Special Bulletin

SP16-303C

WHEELCHAIR LIFT CABLE WEAR

Prevost vehicles

Figure 1

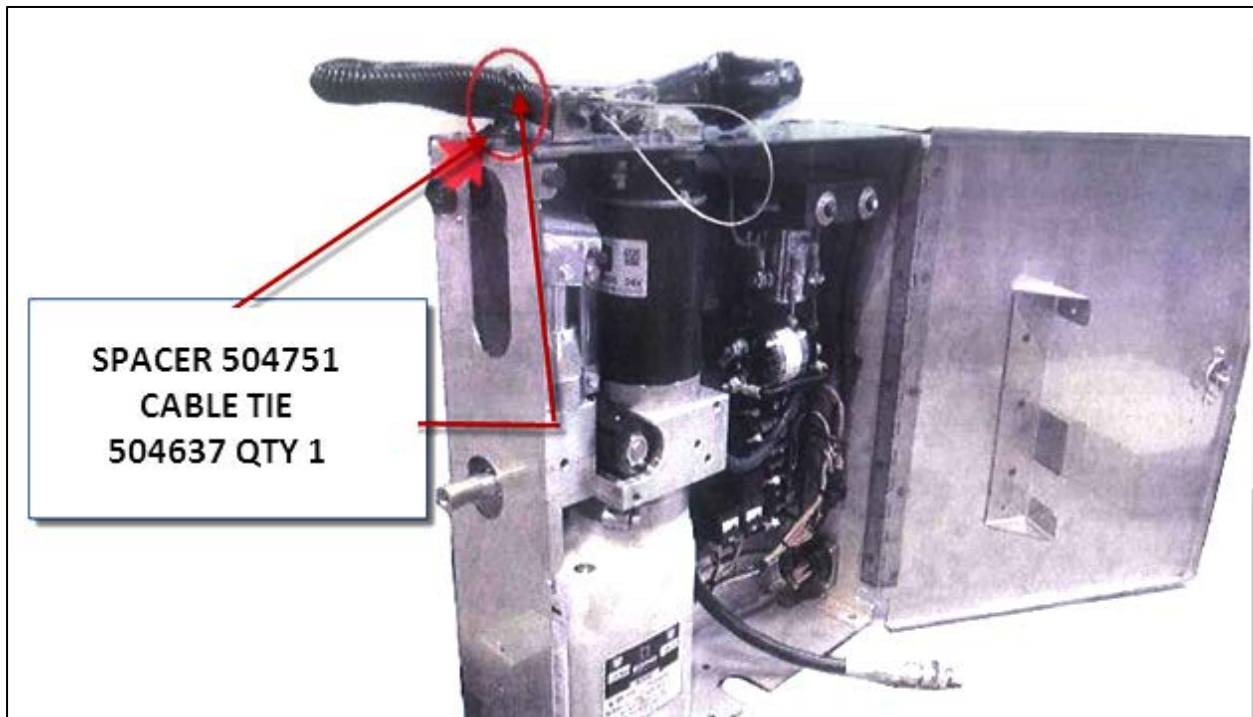
- 1) On the WCL control box of the WCL unit:
- 2) Add electric tape 680319 on the cable sheath to secure the electrical wires inside.
- 3) Add a rotary spacer 504751 on the cable over the electric tape.
- 4) Secure with cable tie 504637 qty 1
